- Subject : Wingflap handle, manual revisions
- Effectivity Type: LS10
Variants: LS10-s, LS10-st
- Accomplishment : Instruction 1 a): Prior to next flight and at repeat at each annual inspection.
1 b), 1 c): Replace when worn.
Instructions 2: Up to April 31. 2012, but latest prior to the next annual inspection.

- Reason : 1. The Locking-plate welded to the wing flap handle 9St9 which acts as a detent for the notches in the wing flap guide plate 9St10 was worn quite quickly on some LS10, see photo on the next page.
To use an even harder material for this plate would be the wrong corrective measure, as then the notches in the wing flap guide plate (not removable) will wear out.
To fix the problem a plate made from brass will be bolted to the wing flap handle 9St9. This plate may be exchanged easily when worn (part 9St9/6).

Locking plate at part 9St9

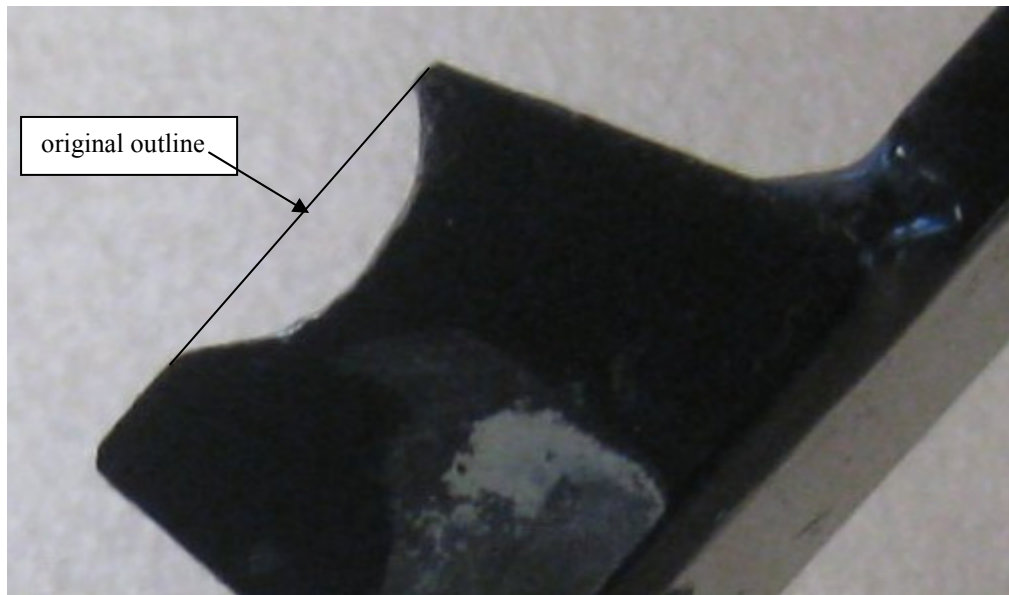
b) If already worn as shown on the picture on page 2 remove the wing flap handle and send it to DG Flugzeugbau for modification. Reinstall the modified item or a new part.

c) Check the locking plate 9St9/6 at each annual inspection and exchange if necessary.
When exchanging the locking plate 9St9/6 it must be fixed with 2 bolts M4x10 DIN933-8.8 BIC to 9St9 and the bolts must be secured with Loctite 243.

Note: Ship the wingflap handle with the riveted in rod-end to DG.

Prior to removal of the handle measure the distance between the front end of pushrod 9St19 (see MM diagram 3) and the axis of the rod-end in 9St9 and adjust to same distance when reassembling.

After reassembling check the wing flap zero adjustment according to MM section 1.4.2 and readjust at the rod-end if necessary.
